Re: Informal Objection - Application
of Jamie Leigh Woods
FCC File No. BPH-910225MH

In Re Application of)
JAMIE LEIGH WOODS) File No. BPH-910225MH
For Construction Permit for)
a New FM Station on FM)
Channel 228A at Rosamond, CA)

INFORMAL OBJECTION 5

ENGINEERING STATEMENT

EXHIBIT 2

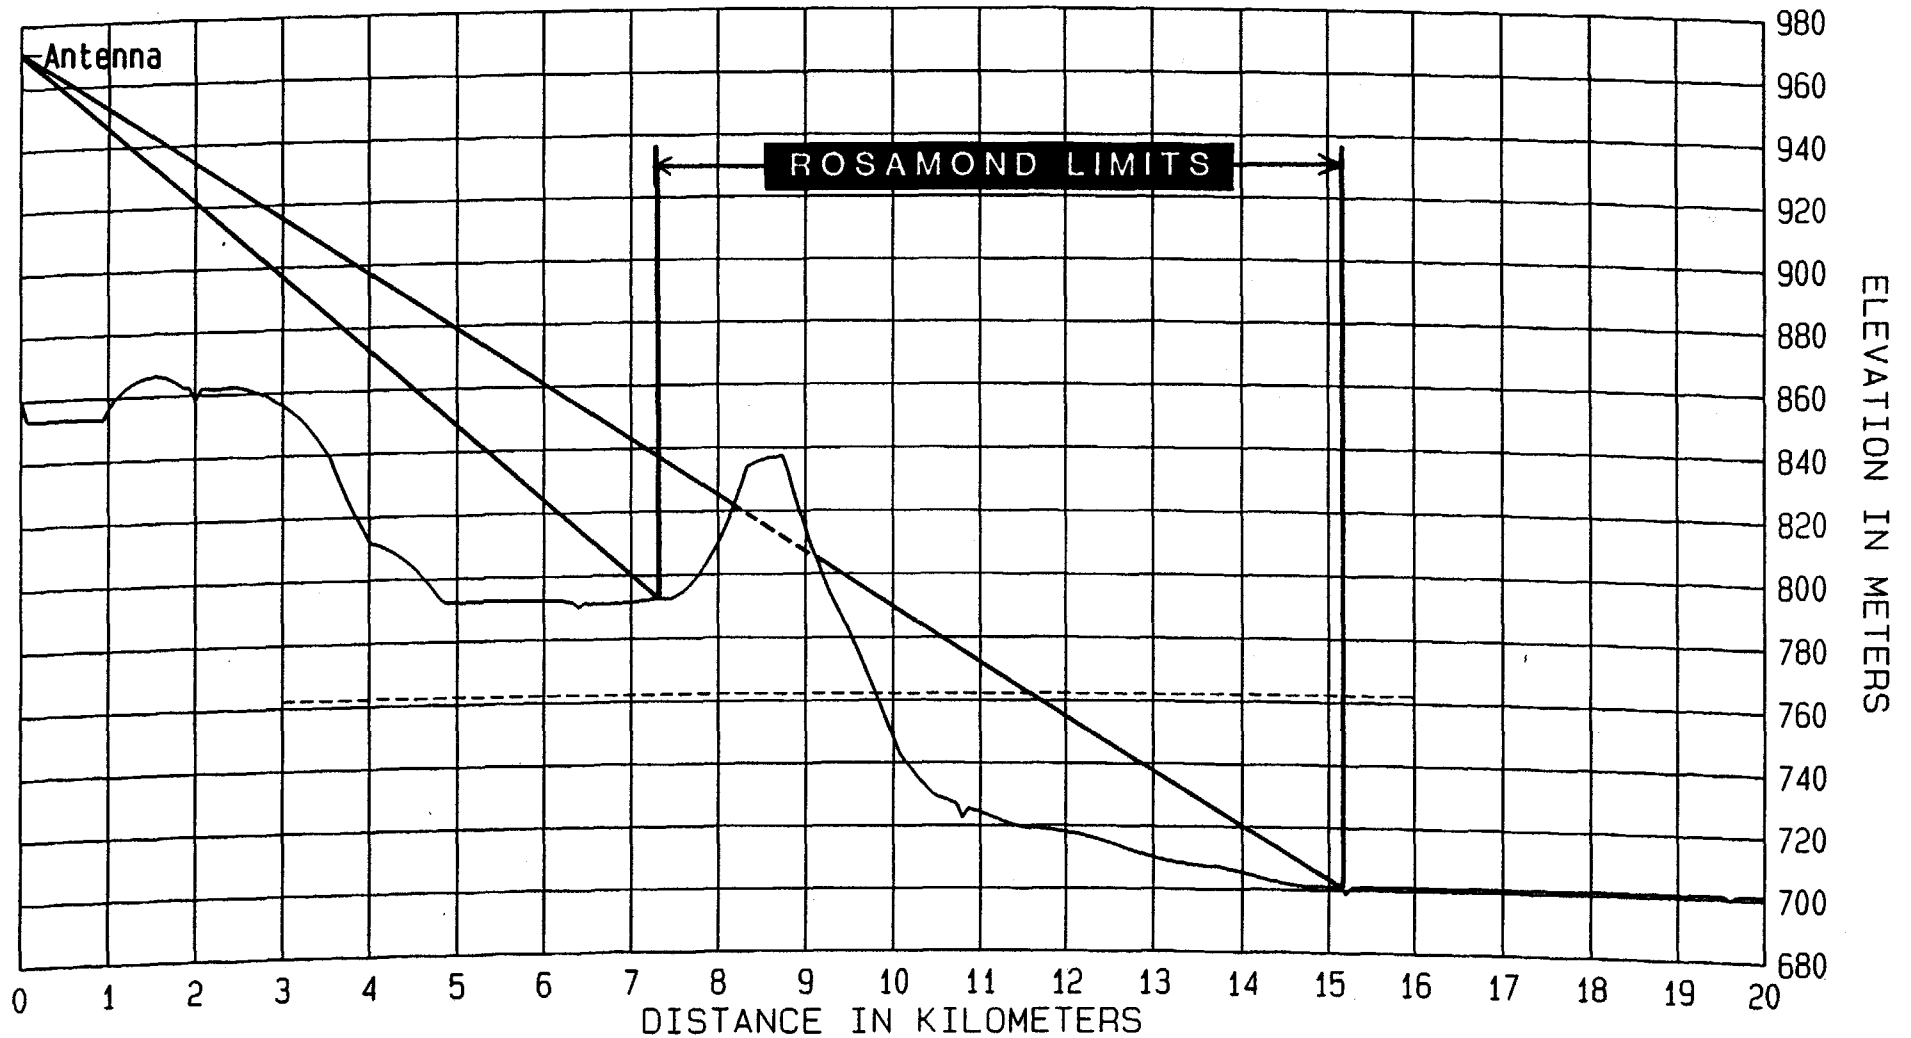
3. This Engineering Statement shows that a major obstruction exists at 8.7km and 2.6km along radials at 135° and 167° true. The Engineering Statement further shows that these obstructions cause significant terrain shielding. Forty four point one percent (44.1%) of the principal community of license lies outside Ms. Leigh's predicted 70 dBu contour as a result of this lack of line of site coverage and terrain shielding.

Terrain profile graphs were generated from the aforementioned database along radials at 135° and 167° True, and are attached as Exhibits 2 and 3, hereto. The portions of these profiles that lie over the Rosamond community limits are indicated on each profile graph. The graphs show predominant terrain obstructions at 8.7 and 2.6 kilometers along the 135° and 167° radials, respectively. These obstructions cause significant terrain shielding over portions of the community of Rosamond.
